# **ALPINE CITY PLANNING COMMISSION MEETING**

SUBJECT: Beck Pines Preliminary Plan

This is the engineering review for the proposed Beck Pines subdivision. The proposed development consists of 19 lots on 11.29 acres. The development is located in the CR 20,000 zone near 621 South Westfield Road, also known as the Beck Properties. A map was created to show this plan in conjunction with Harvest Meadows to give an overall idea of what is being considered for the area.

SUBJECT: Alpine Ridge PRD Concept Plan

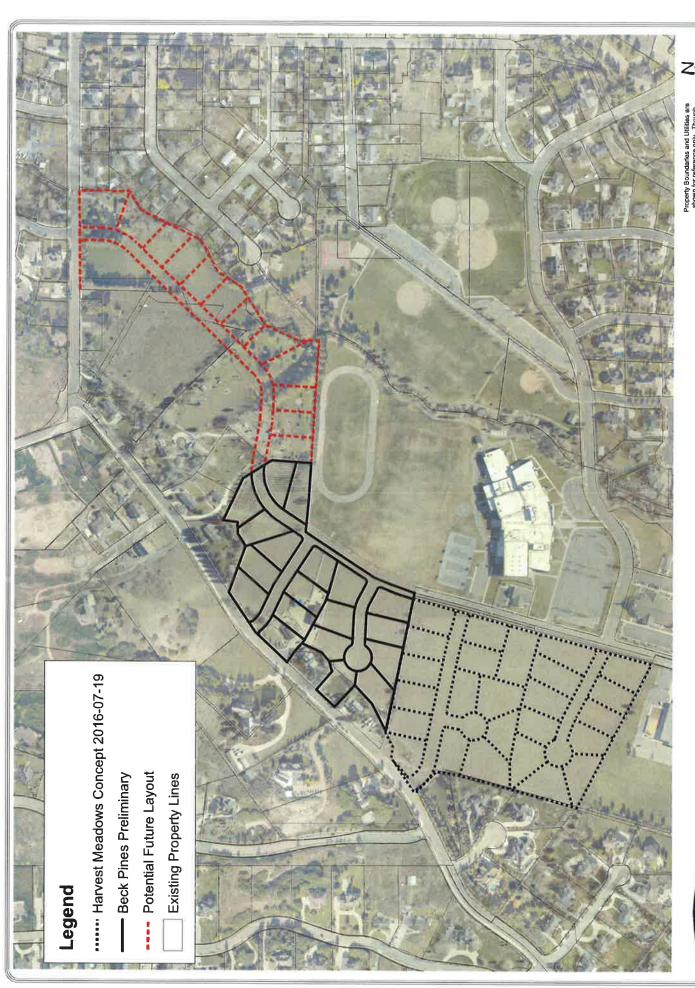
Westfield Ditch runs through the property generally along Westfield Road. Per Dev. Code 4.7.19.1 the ditch is required to be piped through the development and the plans do reflect this. However, the design of the piped ditch runs generally through the middle of the Lot 12. Having utilities through the middle of lots is typically avoided if possible. **Engineering recommends the developer alter the design of the piped ditch as redlined.**

Lot 5 has double frontage. Per Dev. Code 4.7.3.4 double frontage lots are prohibited unless recommended by the Planning Commission and City Council. At Concept it was recommended by the Planning Commission to restrict Westfield Road access for not only Lot 5, but also Lots 12 and 13. Engineering agrees with this recommendation and recommends that access restrictions be clearly labeled on the plat(s).

Besides the larger points of concern mentioned in this report, there are some minor redline corrections on the plans that need addressed.

We recommend that Preliminary Approval of the proposed development be POSTPONED until the following conditions are met:

- Sidewalk is shown to be constructed along the entire frontage of Westfield Road
- A temporary turn-a-round is added to the plans at the northern end of Long Drive
- Remove and cap or re-use the existing sewer lateral off Long Drive
- Remove and cap the existing PI service for Lot 5
- The Developer submit a storm drain system designed for the 50-year storm which discharges to Fort Creek, preferably without the use of sumps
- At Final, the Developer clearly labels Westfield Road access restrictions for Lots 5, 12, and 13 on the plat(s)

ALPINE RIDGE PLANNED RESIDENTIAL DEVELOPMENT

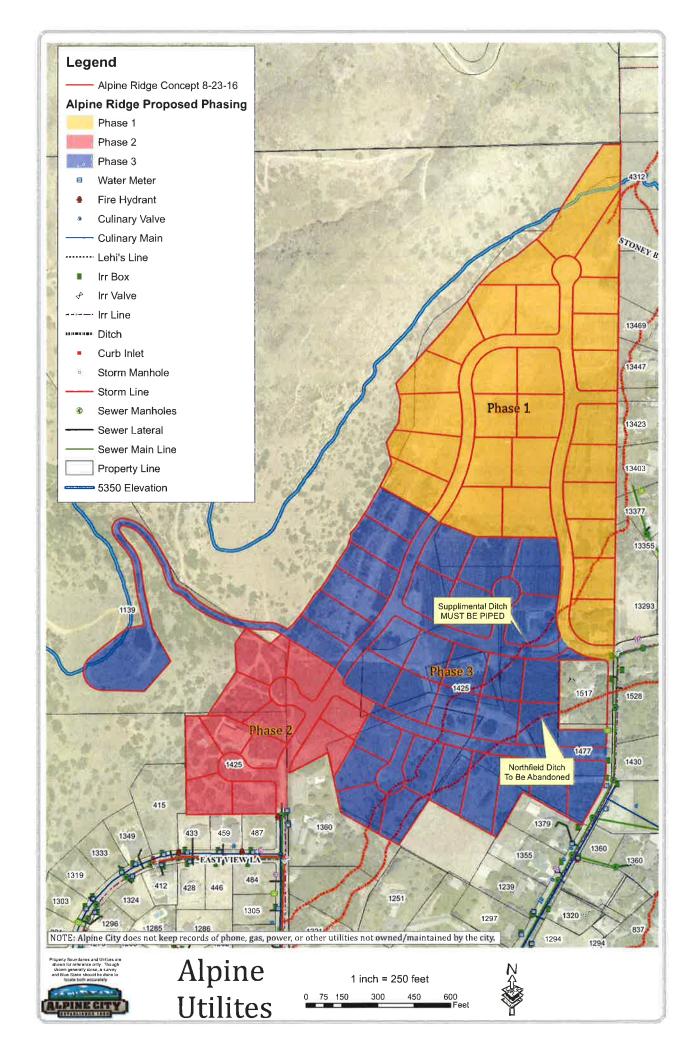
The minimum lot size for lots in the CR-40,000 zone developed as a PRD is 20,000 square feet. The proposed plan meets the requirements but some of the lots will need to be modified to address the issue with the open space calculation. When modifying the lots, each lot shall abut upon and have direct access to an adjacent public street. The width of each lot shall be not less than 90 feet (as measured along a straight line connecting each side lot line at a point 30 feet back from the front lot line). The length of the front lot line abutting the City street shall be no less than 60 feet (Section 3.9.7.6).

The proposed subdivision will include a public trail. The alignment of a trail has not been shown on the plan but the developer is working on finding the best layout in relation to the slope and terrain. The intention is that it will connect the trail at the northwest corner of the Heritage Hills open space and a future trail in the Three Falls Ranch open space.

The recorded conservation easement (68.9 acres) located northwest of the proposed homes gives the City the right to construct and maintain a public trail as part of the Alpine City Trail System, to be located only on the Easement Property and only in the location depicted on Exhibit D of the conservation easement (attached) and subject to some express conditions. The City needs to decide if there will be a trail constructed in this location. If so, the developer needs to show a connection to a public right-of-way somewhere near the proposed "lot 36".

There are several concerns with "lot 69" of the proposed plan. The Engineering Department will cover the concerns with pressurized irrigation and culinary water pressure. Other concerns include but are not limited to the location of the private driveway in relation to the conservation easement, the design of the driveway, access for emergency fire vehicles and compliance with the hillside protection overlay (Section 3.12.9). The City would prefer to eliminate "lot 69" unless the developer can sufficiently address all of the concerns.

The Planning and Zoning Department recommends that approval of the proposed subdivision concept plan be postponed until the following items are addressed:

- The Planning Commission make a recommendation to the City Council and the City Council make a final determination on whether or not the portion of the development outside of the Oberre Annexation should be developed as a Planned Residential Development (PRD).
- If it is determined that the property outside of the Oberre Annexation area is to be developed as a PRD, the Developer needs to provide more open space to meet the minimum 25% of the project requirement.
- The Developer eliminate "lot 69" or sufficiently address the several concerns.
- The Developer change the name of the subdivision.

E:\Engineering\Development\2016\Three Falls Plat Amendment (Plat D)\REVIEW LETTER - Three Falls Plat D,doc

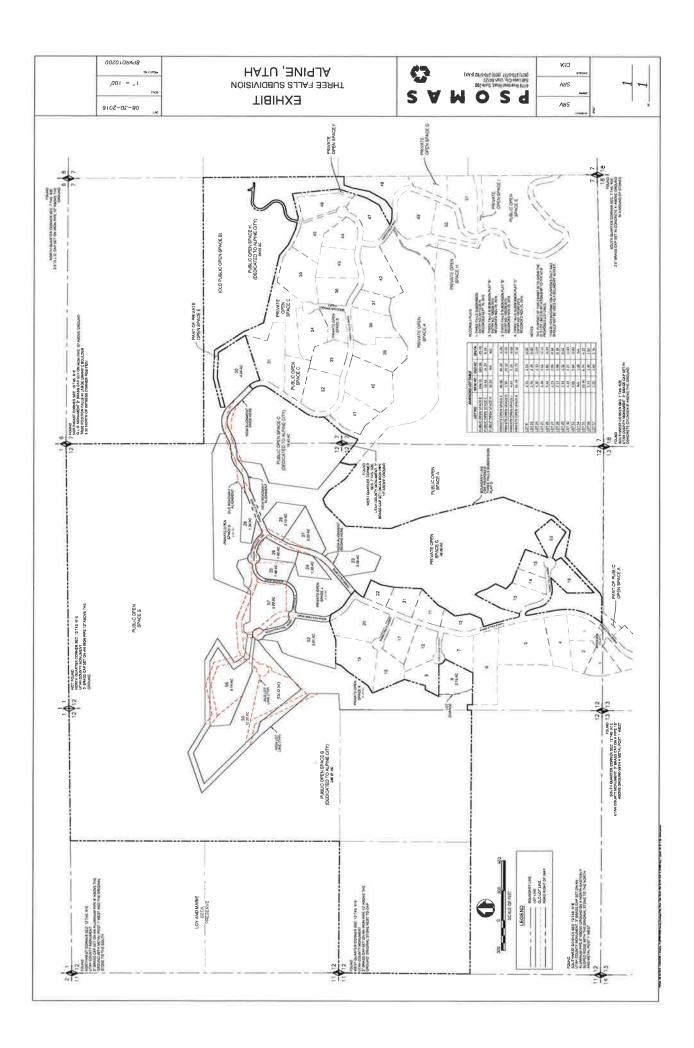
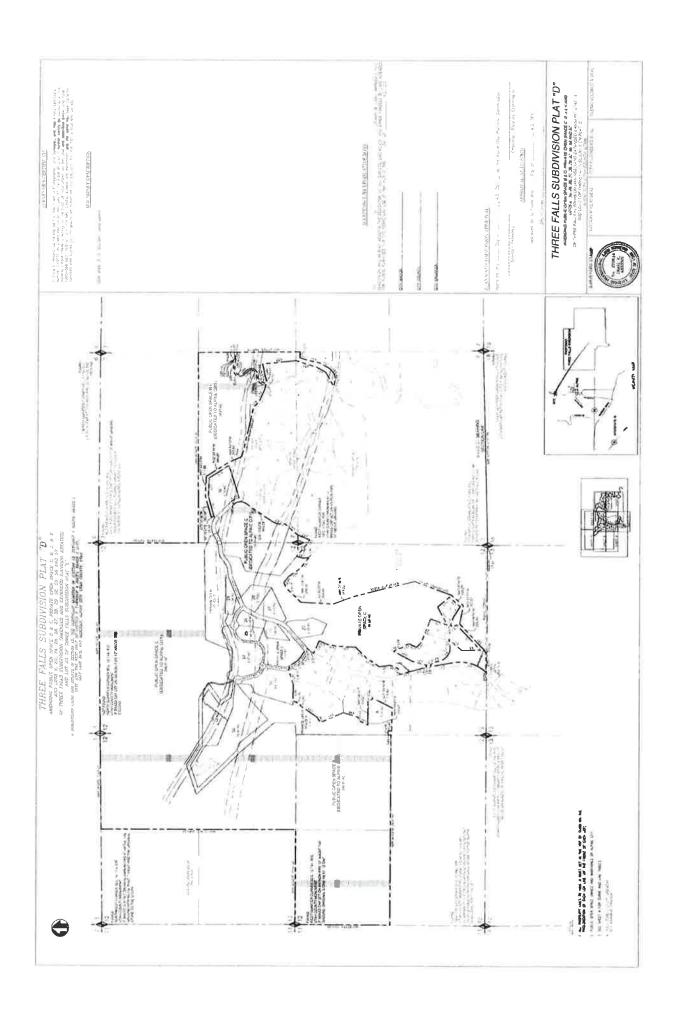
Changing the lots will require an alteration of water policy for the development. The water

policy will need to be met prior to recordation of the plat.

Engineering is in support of the changes as they result in a better design of roads and infrastructure.
